Access Compliance Report

Public Rights-of-Way

(Curb Ramps)

Intersection ID: 7225	Main Street: STATESVILLE_RD	Cross Street: STARITA_RD	Location:	NE
ADA ID: 48A4BA178863	Ramp Type: Perp	Initial Pass/Fail: Fail	Overall Compliance: No	Severity Score: 10
Codes/Mitigation Info/Possible Solution		Field Measurements/Component Compliance

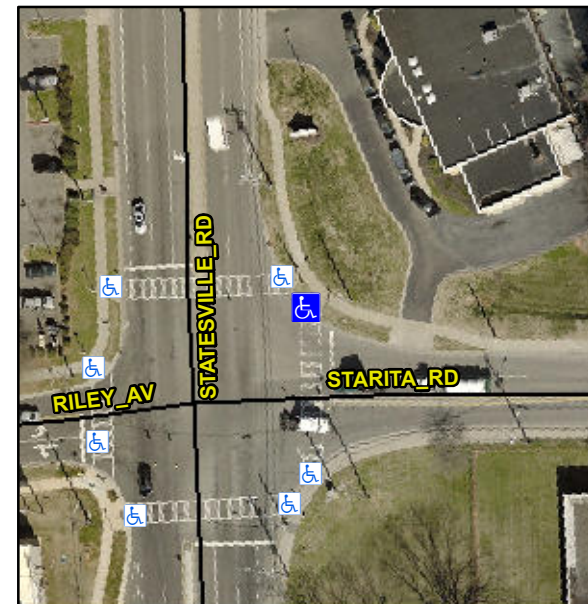
Not Found, R304.5.1, R304.5.3

Compliance	Description	Data	Compliance	Description	Data
N/A	Ramp Length (in)	120.5	Yes	Ramp Slope (%)	7.5
No	Ramp Width (in)	47.0	No	Ramp XSlope (%)	4.3
N/A	Flare Type LT	N/A	N/A	Flare Type RT	N/A
N/A	Flare Slope LT (%)	N/A	N/A	Flare Slope RT (%)	N/A
N/A	Flare Traversable LT?	N/A	N/A	Flare Traversable RT?	N/A
N/A	Landing Length (in)	N/A	N/A	DWS Provided?	N/A
N/A	Landing Width (in)	N/A	N/A	DWS Contrast?	N/A
N/A	Landing Slope (%)	N/A	N/A	DWS Length (in)	N/A
N/A	Landing X Slope (%)	N/A	N/A	DWS Full Width?	N/A
N/A	Landing Curb? (Y/N)	N/A	N/A	DWS Offset (in)	N/A
N/A	Shared Landing?	N/A			
N/A	Gutter Ponding?	N/A	N/A	Gutter Slope (%)	N/A
N/A	Gutter Lip Ht (in)	N/A	N/A	Gutter X Slope (%)	N/A
N/A	Painted X Walk1?	Yes	N/A	Painted X Walk2?	N/A
	X Walk 1 Direction	To S		X Walk 2 Direction	N/A
N/A	X Walk 1 Width (in)	110.0	N/A	X Walk 2 Width (in)	N/A
	X Walk 1 Slope (%)	5.0		X Walk 2 Slope (%)	N/A
	X Walk 1 X Slope (%)	4.2		X Walk 2 X Slope (%)	N/A

Remove & Replace Entire Ramp.
